SUBJECT: REZONING TO PUD COMMENTS LETTER

PROJECT NAME: DEER PATH NORTH PHASE 2

PROJECT #2008070033 APPLICATION #26219 PARCEL #31865-000-00

Deer Path North Phase 2
Residential Concept
MARION COUNTY, FLORIDA

VICINITY MAP
NOT TO SCALE

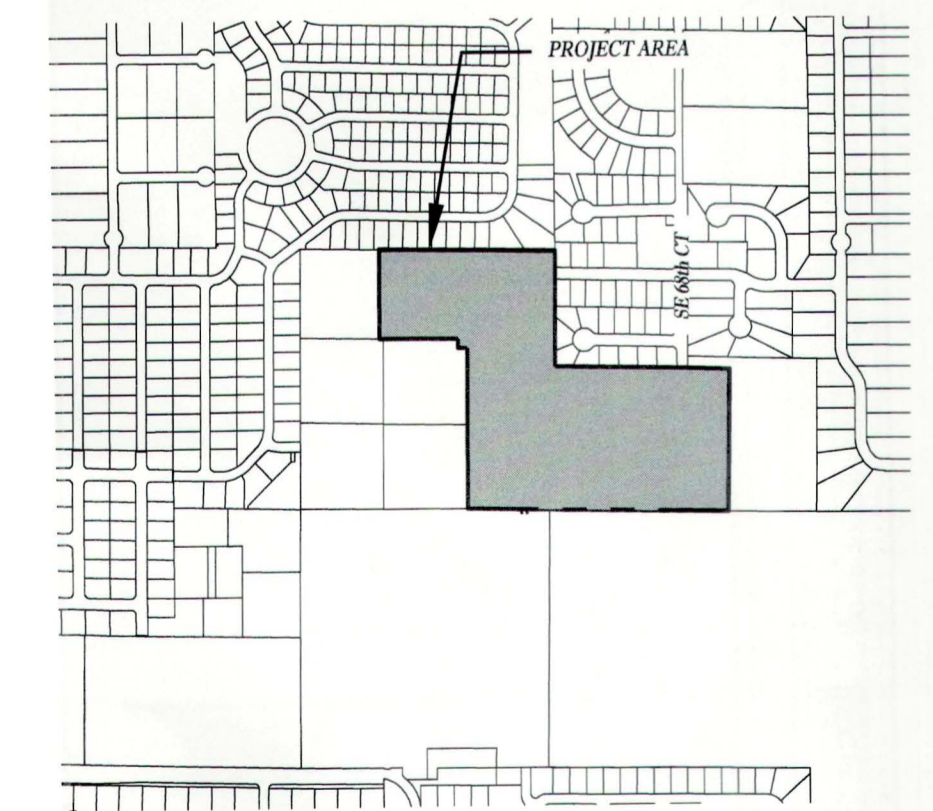
4. DEPARTMENT: ENGIN - DEVELOPMENT REVIEW
REVIEW ITEM: 4.2.31.F(2)(b)2 - Vicinity map that depicts relationship of the site to the surrounding area within a 1 mile radius
STATUS OF REVIEW: INFO
REMARKS: 2/27/21 - Provide surrounding street names

26. DEPARTMENT: ZONE - ZONING DEPARTMENT
REVIEW ITEM: 4.2.31.F(2)(b)(2) - Vicinity map that depicts relationship of the site to the surrounding area within a 1-mile radius.
STATUS OF REVIEW: INFO
REMARKS: Locator map extends about .3 miles.

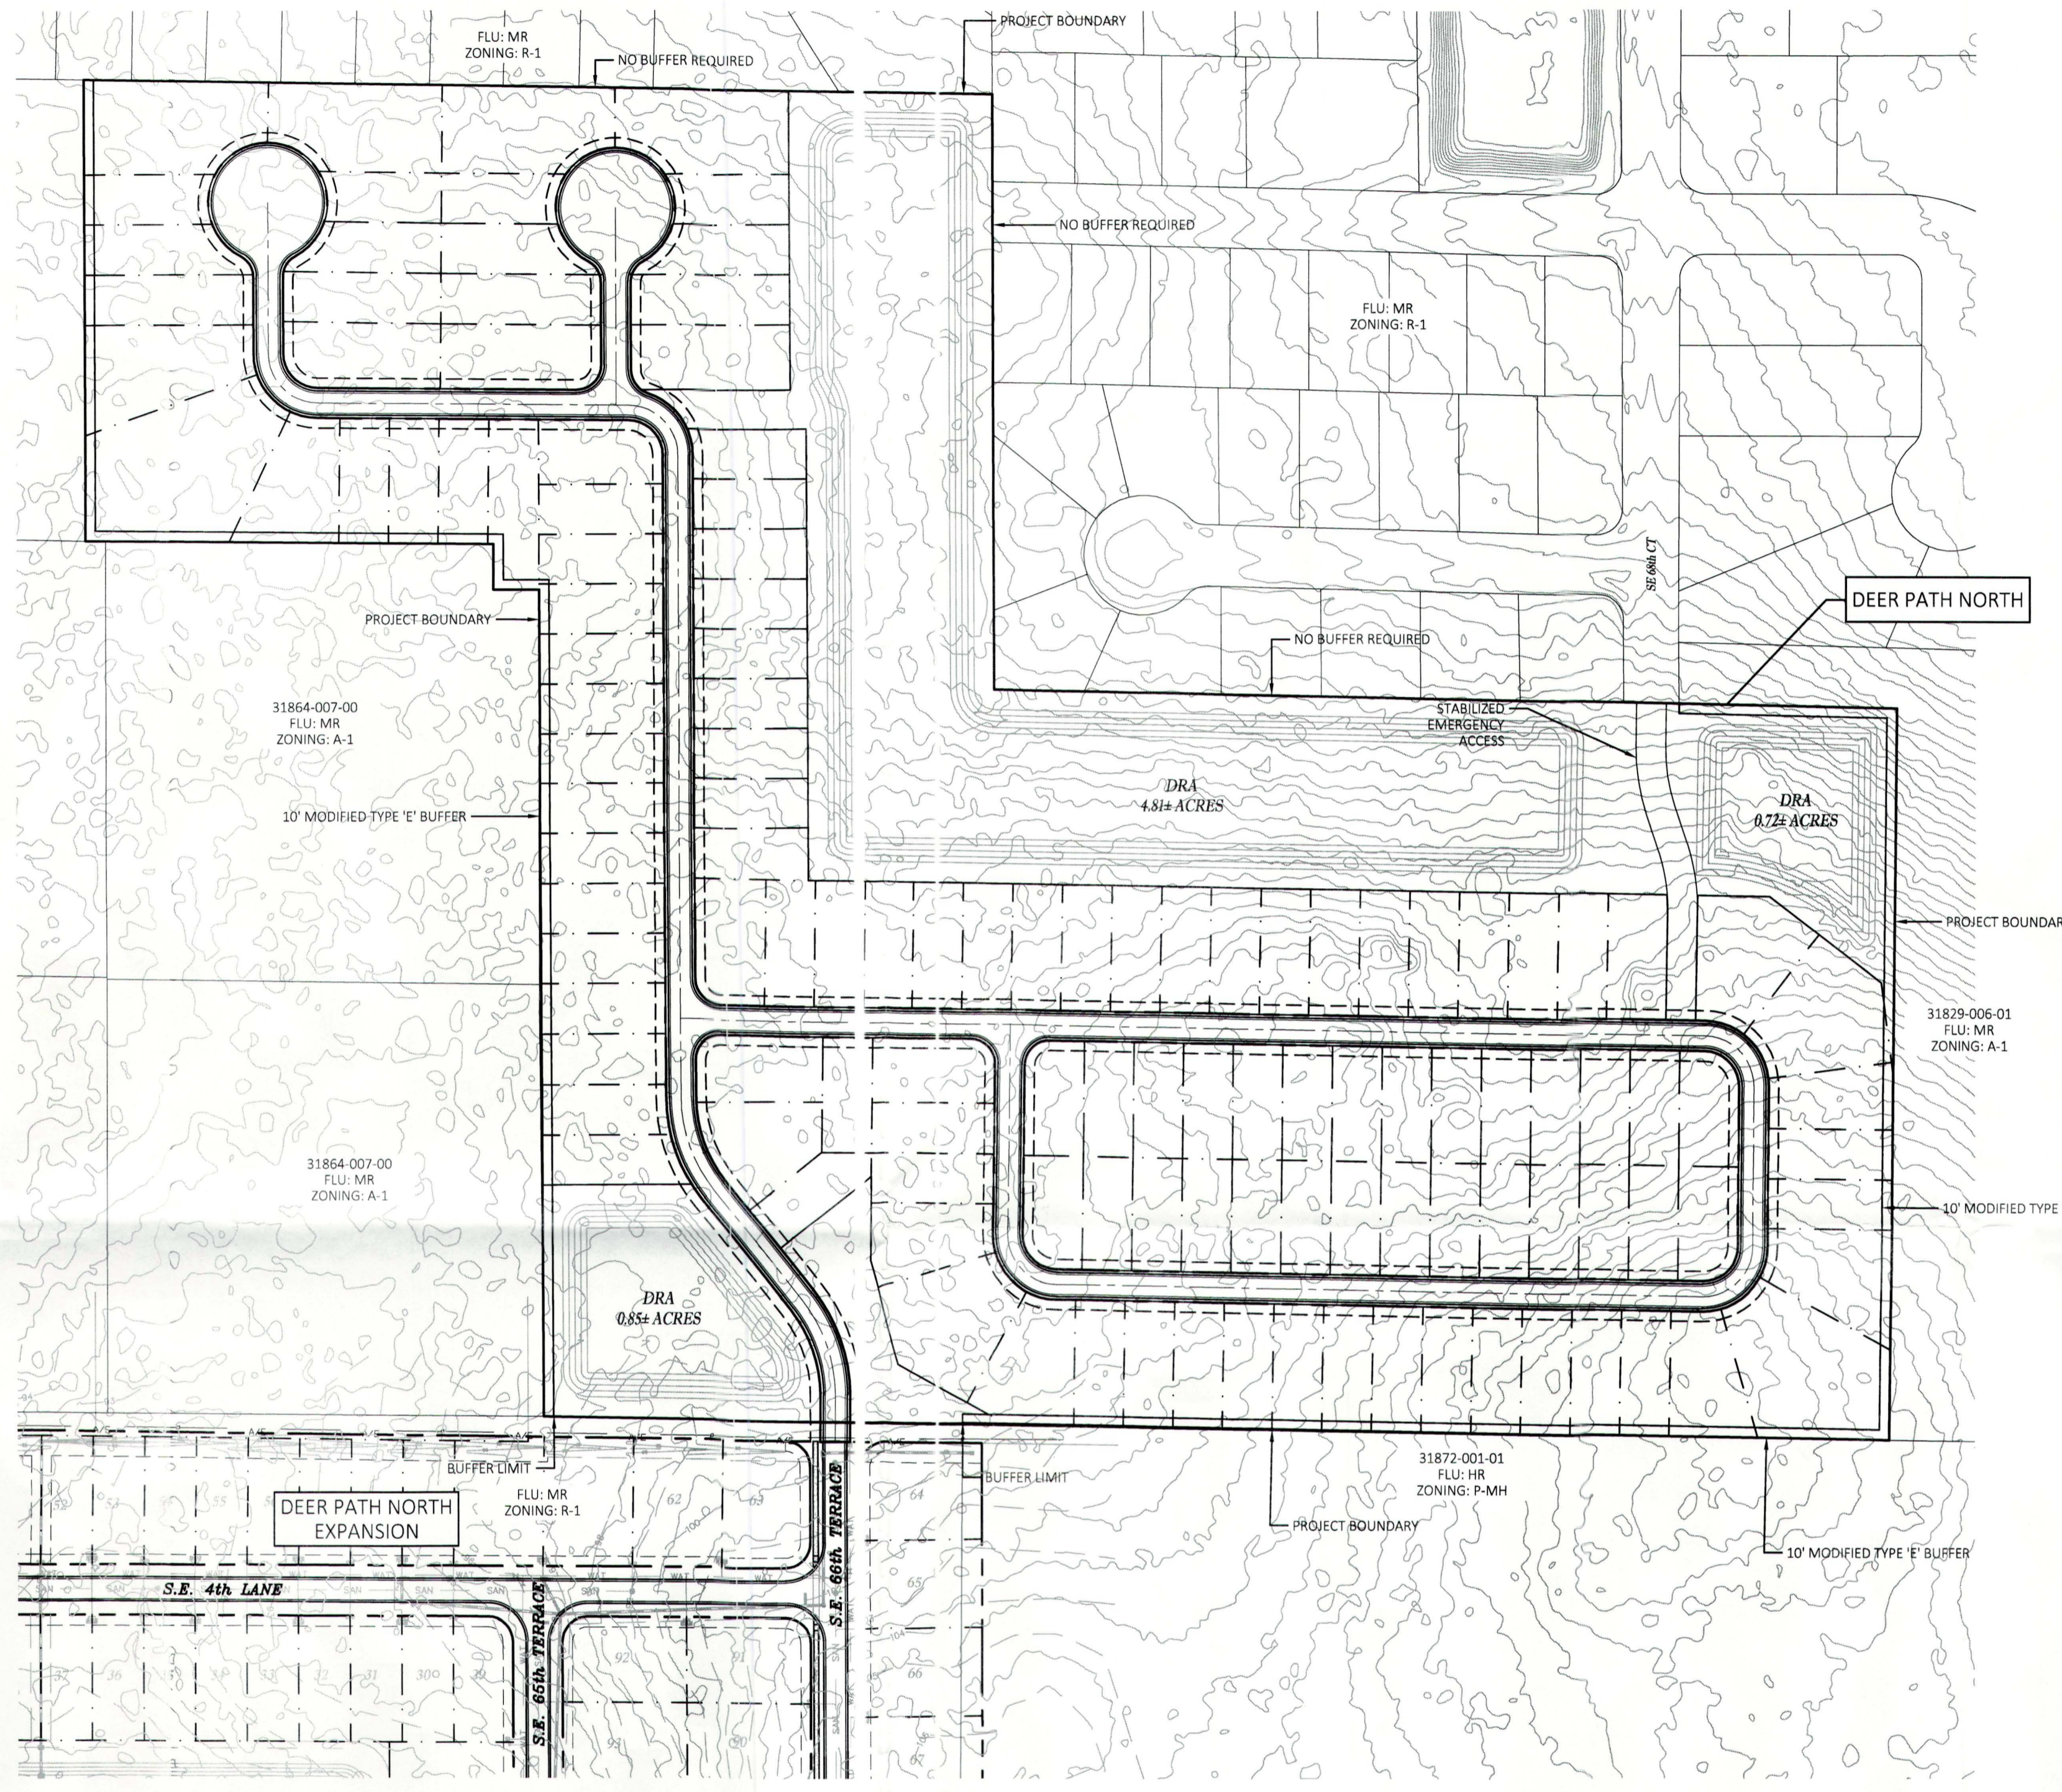
2. DEPARTMENT: ENGDRN - STORMWATER REVIEW
REVIEW ITEM: Rezoning
STATUS OF REVIEW: INFO
REMARKS: INFO. Stormwater is not opposed to the Rezoning for this new SFR subdivision. The rear setback of 10' may be an issue if storm pipes will be located in rear yards. 20' drainage easement width is needed by code.

3. DEPARTMENT: ENGIN - DEVELOPMENT REVIEW
REVIEW ITEM: 4.2.31.F(2)(b)1 - The name of the proposed PUD shall be centered at the top of the sheet along the long dimension of the sheet
STATUS OF REVIEW: INFO
REMARKS: 2/27/21 - Project name is not along top of page

9. DEPARTMENT: ENGTRF - TRAFFIC REVIEW
REVIEW ITEM: 4.2.31.F(2)(b)(17) - Show any proposed land or right-of-way dedication
STATUS OF REVIEW: INFO
REMARKS: The proposed right-of-way for the subdivision street appears to be only 30ft wide with 10ft easements on each side. The requirement is 50ft wide with 5ft easements on each side.

12. DEPARTMENT: LUCURR - LAND USE CURRENT REVIEW
REVIEW ITEM: Proposed PUD Uses & Densities are consistent with Land Use Designation?
STATUS OF REVIEW: INFO
REMARKS: Less than 4 du/ac is proposed (with exception of note about "8 allowable units" under proposed zoning description which may be in error).

13. DEPARTMENT: LUCURR - LAND USE CURRENT REVIEW
REVIEW ITEM: Proposed PUD Master Plan submitted for review?
STATUS OF REVIEW: INFO
REMARKS: There may be typos: "8 allowable units" and "proposed future land use MR-High Residential".

15. DEPARTMENT: LUCURR - LAND USE CURRENT REVIEW
REVIEW ITEM: [6.12.2.A - Local Road right-of-Way Provided?]
STATUS OF REVIEW: INFO
REMARKS: Roadway width does not appear to meet minimum widths (especially with sidewalk on one side) but will defer to Engineering/Traffic.

17. DEPARTMENT: LUCURR - LAND USE CURRENT REVIEW
REVIEW ITEM: [6.11.4.C - Additional/Interconnected Access (S/QS-L) Provided?]
STATUS OF REVIEW: INFO
REMARKS: LDC Sec 6.11.4 requires two access pts for more than 50 lots. Only one access is proposed, with an additional one proposed for emergency access to the north.

18. DEPARTMENT: LUCURR - LAND USE CURRENT REVIEW
REVIEW ITEM: 6.12.12 - Sidewalks Internal/External Provided?
STATUS OF REVIEW: INFO
REMARKS: Sidewalks are proposed on one-side of roadway but not delineated, and unclear if this is for all roadways.

25. DEPARTMENT: ZONE - ZONING DEPARTMENT
REVIEW ITEM: 4.2.31.F(2)(b)(1) - The name of the proposed PUD shall be centered at the top of the sheet along the long dimension of the sheet.
STATUS OF REVIEW: INFO
REMARKS: Name to be at top of sheet, centered.

27. DEPARTMENT: ZONE - ZONING DEPARTMENT
REVIEW ITEM: 4.2.31.F(2)(b)(3) - Drawing of the boundaries of the property showing dimensions of all sides.
STATUS OF REVIEW: INFO
REMARKS: Boundary dimensions not shown.

30. DEPARTMENT: ZONE - ZONING DEPARTMENT
 REVIEW ITEM: 4.2.31.F(2)(b)(18) / 4.2.31.E(7) - Identify any proposed parks or open spaces.
 STATUS OF REVIEW: INFO
 REMARKS: Park areas not identified. Open space less than required.

34. DEPARTMENT: 911 - 911 MANAGEMENT
 REVIEW ITEM: Rezoning
 STATUS OF REVIEW: INFO
 REMARKS: APPROVED - Please be aware that on the Conceptual Plan there are two parcel labels for 31864-007-00. The northern one is incorrect and should be 31864-004-00. This must be corrected on any future plats to avoid rejection.

TYPICAL 50' X 115' LOT
N.T.S.

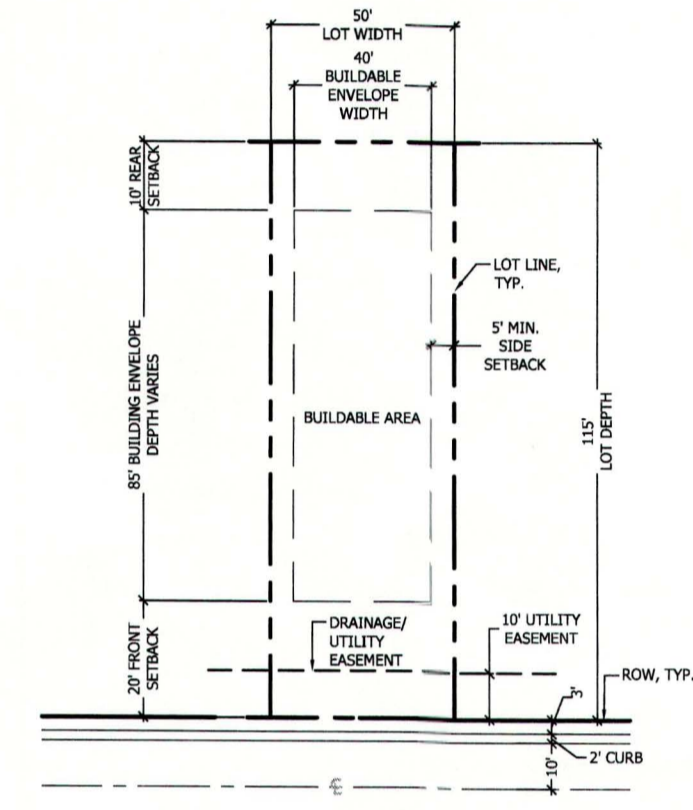
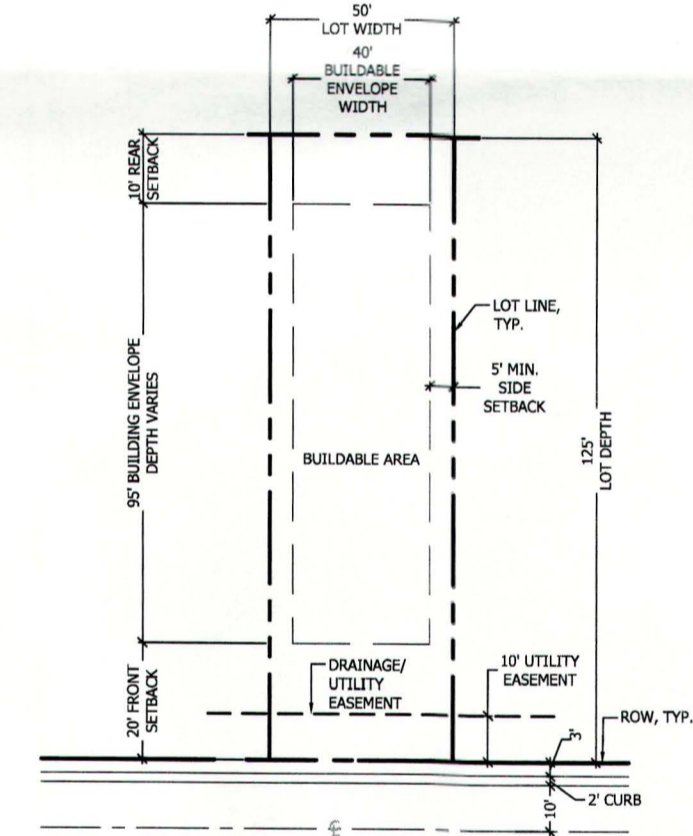
8. DEPARTMENT: ENGTRF - TRAFFIC REVIEW
REVIEW ITEM: 4.2.31.F(2)(b)(14) - Preliminary sidewalk and multimodal circulation plan
STATUS OF REVIEW: INFO
REMARKS: The plans calls for the construction of sidewalk on one side of the street as required by the code, but it also provides for a building setback of 20 feet with the right-of-way line at the back of the curb. This will only leave about 14 feet from the home to the sidewalk. Code requires the driveway to measure a minimum of 25 feet from the face of the garage to the sidewalk. 25 feet is the standard design length for a passenger car.

28. DEPARTMENT: ZONE - ZONING DEPARTMENT
REVIEW ITEM: 4.2.31.F(2)(b)(8) / 4.2.31.F(2)(13) - A typical drawing of an interior lot, corner lot, and cul-de-sac lot noting setback requirements and parking lot locations.
STATUS OF REVIEW: INFO
REMARKS: Interior lot typicals provided. Need corner lot and cul-de-sac lot typicals.

29. DEPARTMENT: ZONE - ZONING DEPARTMENT
REVIEW ITEM: 4.2.31.F(2)(b)(9) - Proposed zoning and development standards (setbacks, FAR, building height, ect.).
STATUS OF REVIEW: INFO
REMARKS: Setbacks shown. Will there be a separate setback for accessories? Is there a height limit?

ARCHITECTURAL STYLE

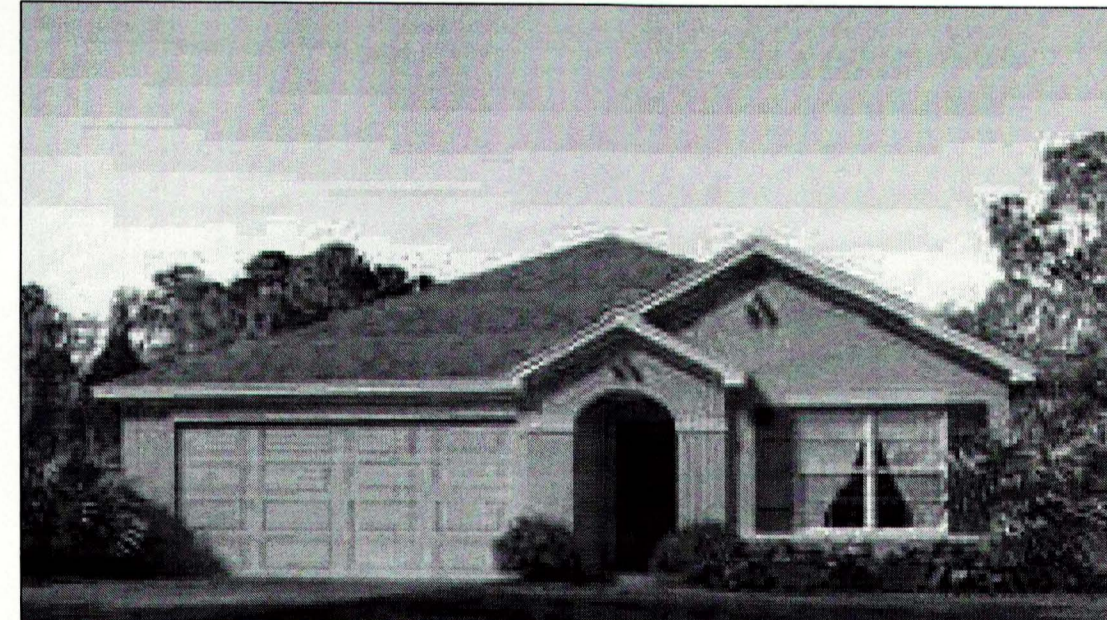
31. DEPARTMENT: ZONE - ZONING DEPARTMENT
 REVIEW ITEM: 4.2.31.F(2)(b)(20) - Architectural renderings or color photos detailing the design features, color pallets, buffering details.
 STATUS OF REVIEW: INFO
 REMARKS: Black & White photo included; no design details.
